HISTORIC PRESERVATION BOARD

PUBLIC HEARING
30-32 ATLANTIC STREET

TO: Chair Pollard and Members of the Historic Preservation Board
FROM: Rob Wiener, Historic Preservation Compliance Coordinator
DATE: November 12, 2021
RE: November 17, 2021 **PUBLIC HEARING – Final Review of Proposed
Multifamily Residential Infill Construction
HPBR-001790-2021**

Re: 30-32 Atlantic Street, design changes since 10/06/21 HP workshop

① Roof Plan
1/4" = 1'-0"

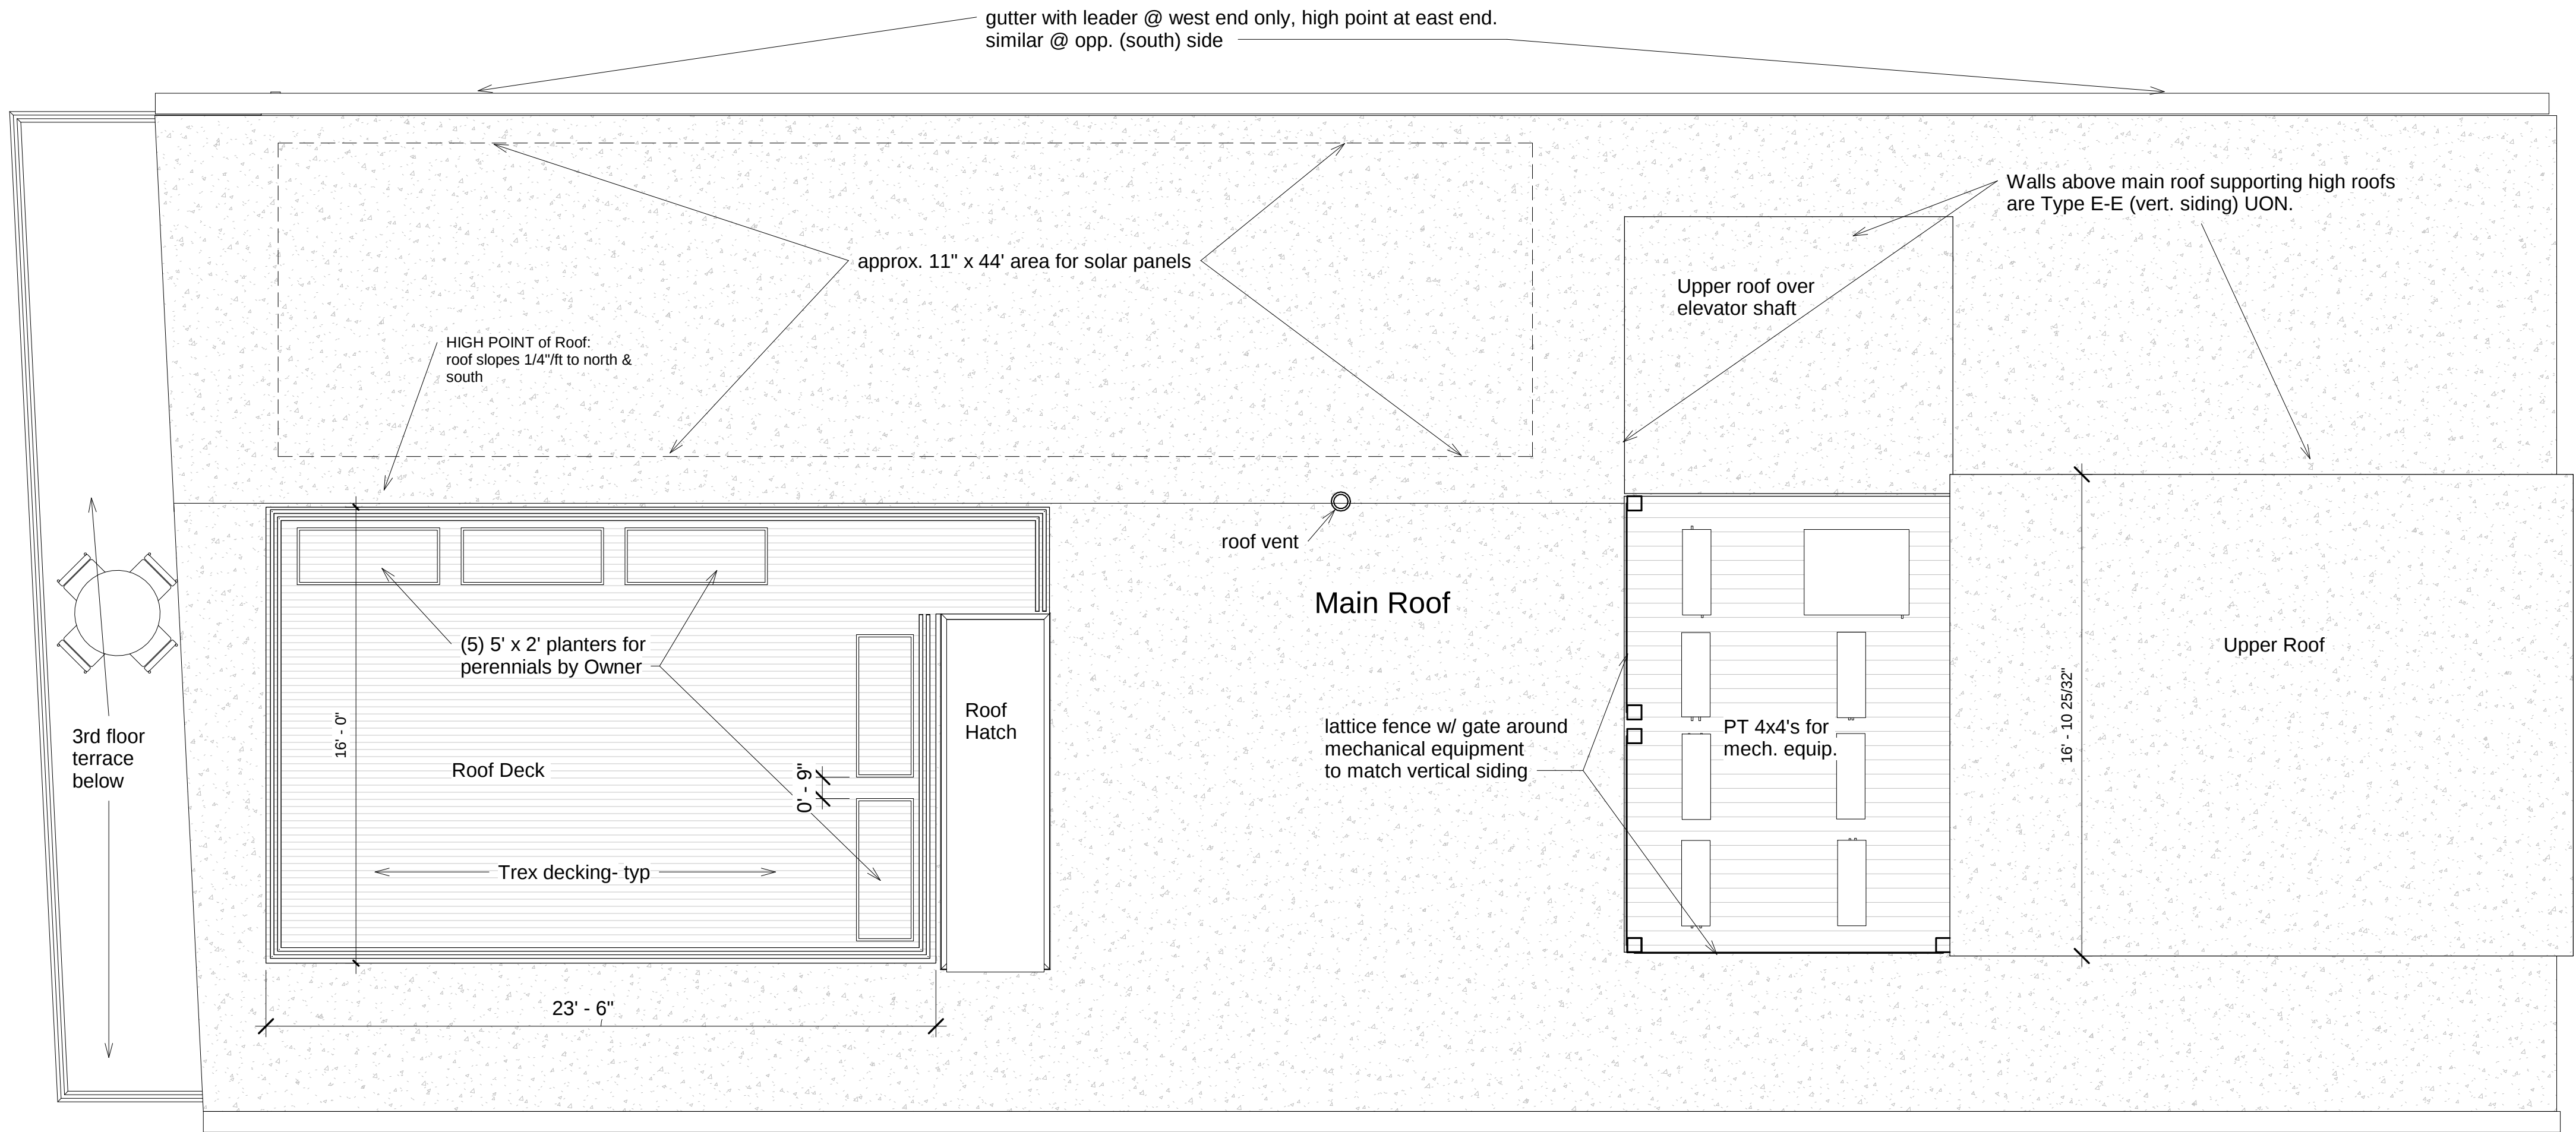
- Members questioned the use of roof trees for screening.
- The entry and the design could benefit from greater prominence for the entry.

1. The *Stair Bulkhead* has been deleted. The access to the roof is now provided by a roof hatch over an internal stair and will be a low bulkhead hatch on the roof (top of hatch at 12" +/- above the main roof level). For all intents and purposes, this hatch would not be seen from the street from any vantage point. The available space for photovoltaic panels is now expanded as a result of deleting the roof stair bulkhead.

2. The *Rooftop Deck* is now simplified to be a simple rectangle and has shifted to the west by a few feet.
3. The *Rooftop Planters* between the raised Bay Roof and the mechanical equipment have been eliminated; the remaining planters at the roof deck will have low perennials or herbs (not visible from the street).

4. *Mechanical Units* on the roof are now screened with a simple lattice wall that will be similar to the vertical siding.
5. A *Cornice* detail has been added to clarify the dimensions of the cornice. Please note that the overall height of the cornice is required to conceal the slope of the roof from its high point at the center to its low points along the north and south walls; while technically a flat roof, it is slightly pitched to north and south sides for run-off. See detail 4/A403.

1 Proposed East Elevation
3/16" = 1'-0"

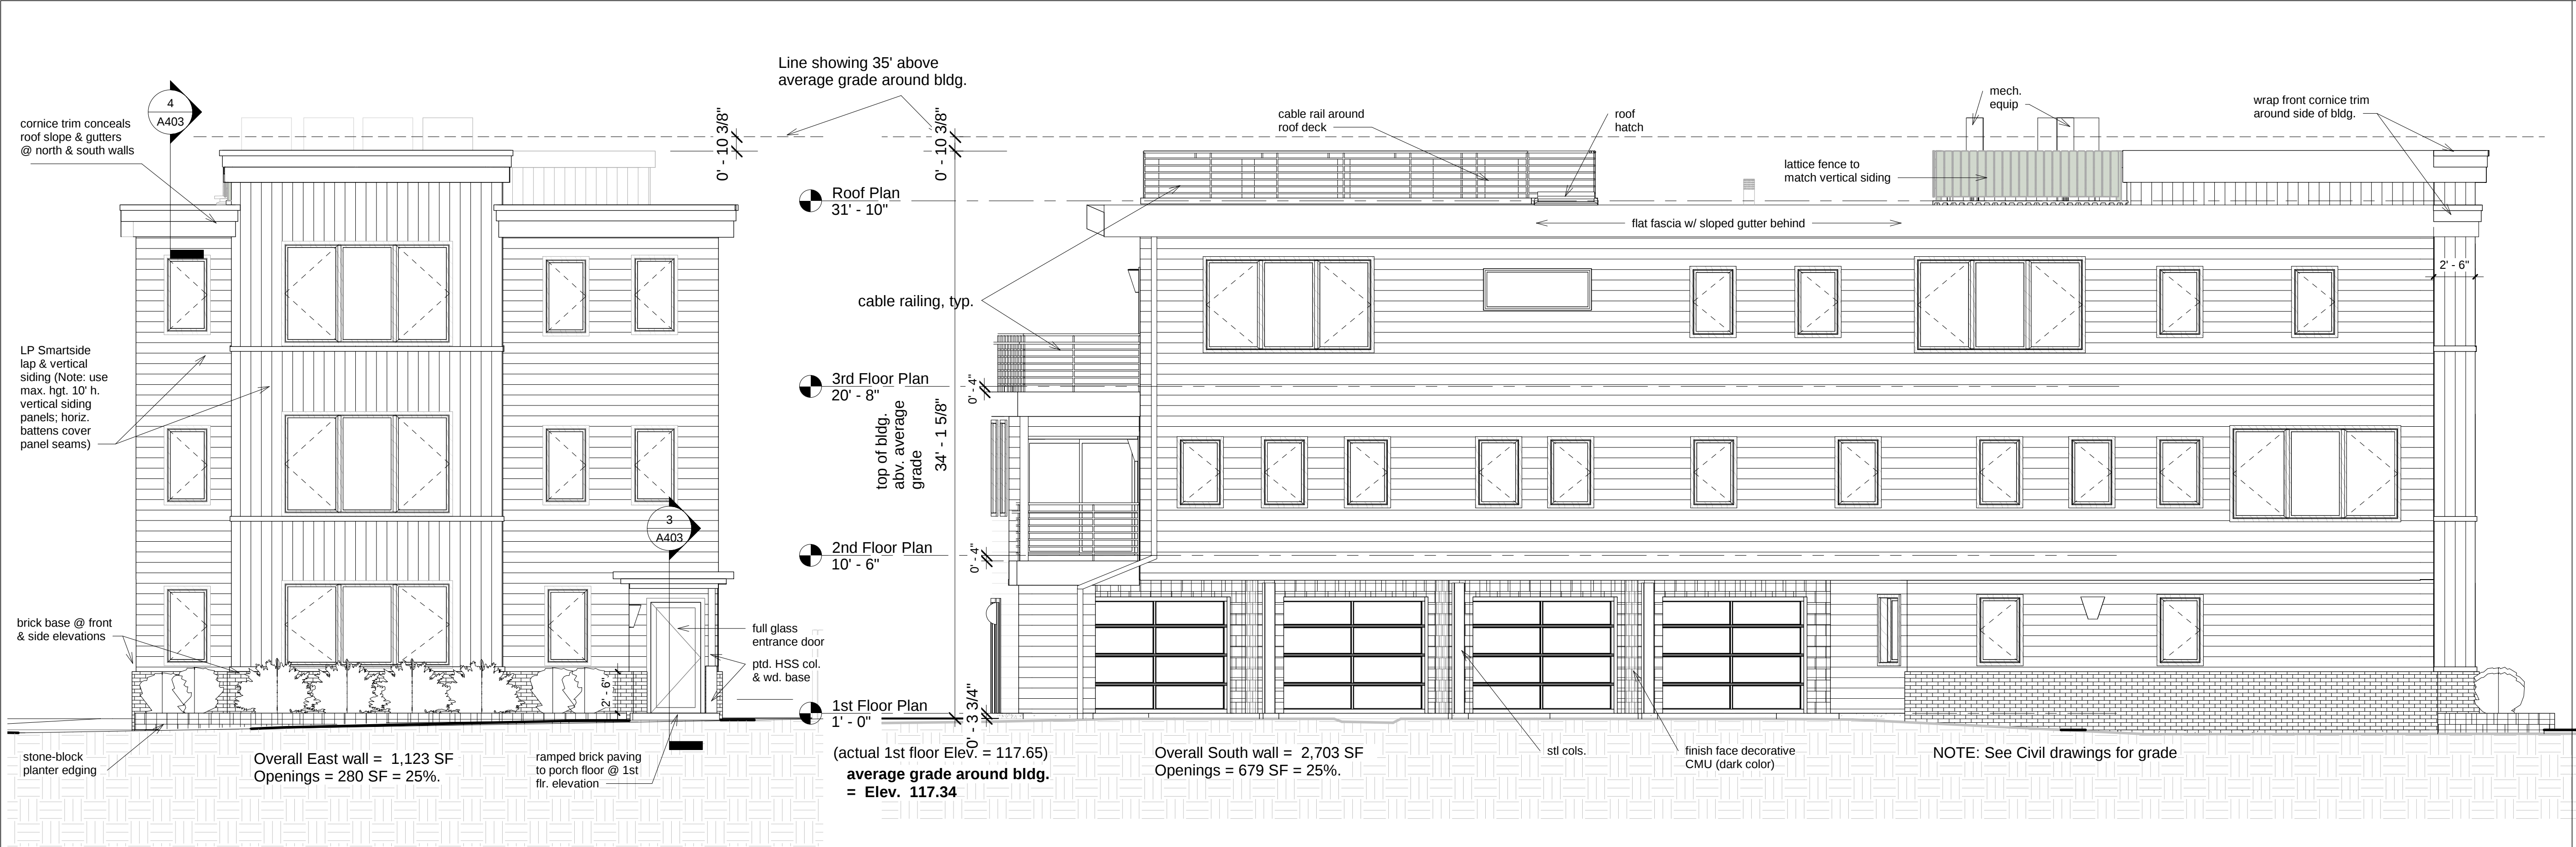
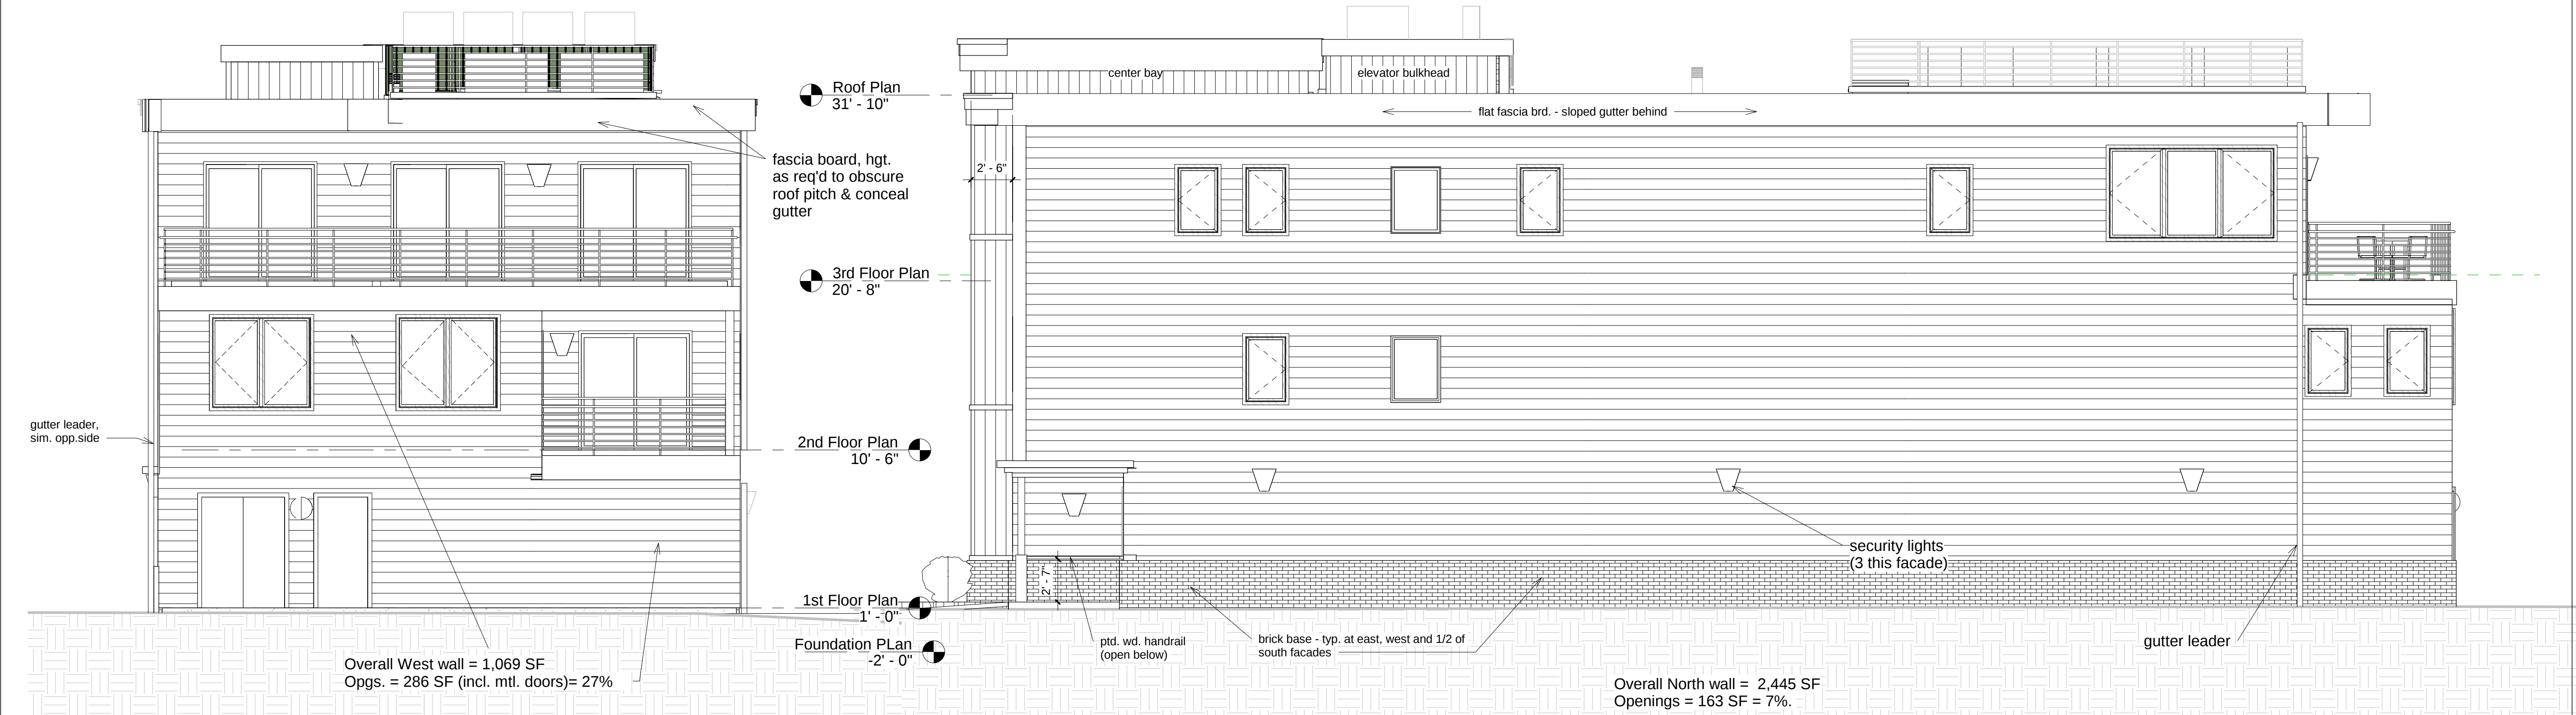
- The front entrance has gained a degree of greater prominence since the workshop. Would it be worth considering giving it greater emphasis? Would a more substantial cornice over the entry help?
- Staff believes that on the front (east) facade the changes to the brick base, the window sizes, the horizontal trim bands, and the front planter have all contributed to a better-balanced composition that more successfully meets the Standards. Do Board members think more should be done to make it a compatible façade?
- On the north and south facades, the contrast between the smaller, single windows and large, mullied units is pronounced when seen in the elevations. On these

secondary faces, perhaps it is not as important to achieve the same balance and rhythm as on the front façade.

- On the north face, two fixed windows opposite the elevator (2nd and 3rd floors) are slightly wider than the other single windows. These seem to be the only two windows of this type, but on this less visible face the break with the pattern may be of little consequence.

- On the south face, a new window type has been introduced quite far from the front of the building: a wide window adds light to the newly added interior stairs to the roof. This may be minimally visible from the street, but if there are concerns about the pronounced horizontal orientation of this opening, perhaps it could be divided into two units, either mullied or separated.

2. The *Front Bay Window* heights have been revised: the 1st floor is now taller at 5' h.; the 2nd & 3rd floors are now the same height at 6'. The single-unit front windows have been increased in height from 4' to 4'-6" h. The overall impact is an increase from 265 SF of window/door area to 280 SF = 9% additional window area on the east elevation.

3. The *Brick Wall Base* has been raised to be approximately 30" - 34" high (height changes with grade; the datum is that top of brick at 30" above entrance porch floor/first floor level).

5. The *Horizontal Banding* at the vertical siding at the central bay is now aligned with the bottom of the triple bay windows. A band has been added below the first floor bay windows, between the top of brick and the window sill. (Please note that banding is required because the vertical siding panels come in maximum 10' lengths' so the banding covers the horizontal joints between panels.)
